Section 78

Scope of works (revised)

31 July 2019

Independent Expert Review of the Acid Sulfate Soil Preferred Management Options for Yeodene Swamp

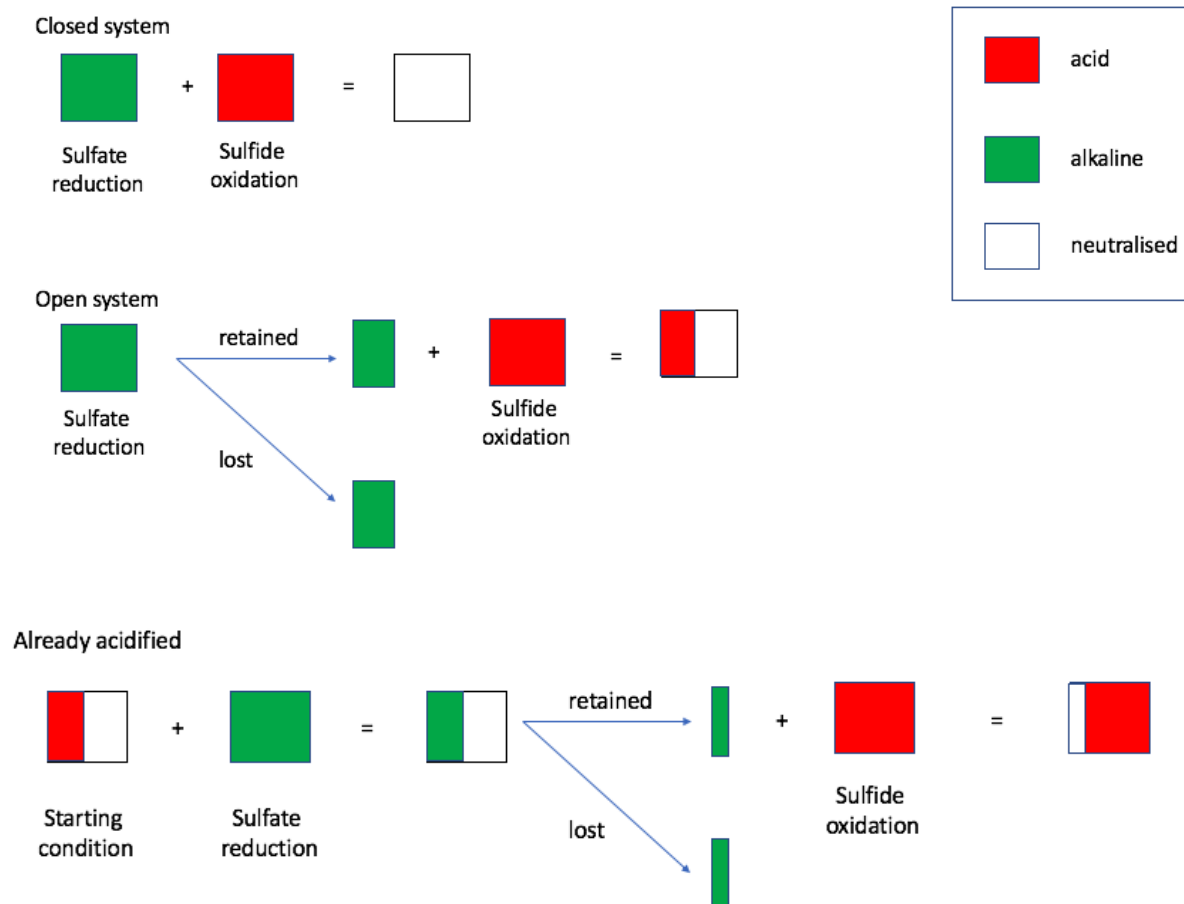
Because Yeodene is an open system that does not retain all of the alkalinity produced during ASS formation, the approach of inundating Yeodene Swamp, and only relying on alkalinity created during new ASS formation to neutralise acidity produced in previous ASS formation events, is flawed. It creates a pool of ASS in the swamp that doesn't have any associated neutralising capacity associated with it, because this neutralising capacity has already been used up to neutralise previous acidity - a bit like robbing Peter to pay Paul (Figure 1). When the swamp dries out again, there will be another acidification event.

It is highly likely Yeodene Swamp will dry out in the future, notwithstanding the introduction of the proposed barrier and new flow rules downstream of McDonald's Dam. The drying of Yeodene Swamp will most likely be caused by three factors - a drying climate, lowering of the water table through groundwater extraction, and the operation of McDonald's Dam - all often acting at the same time during extended periods of drought.
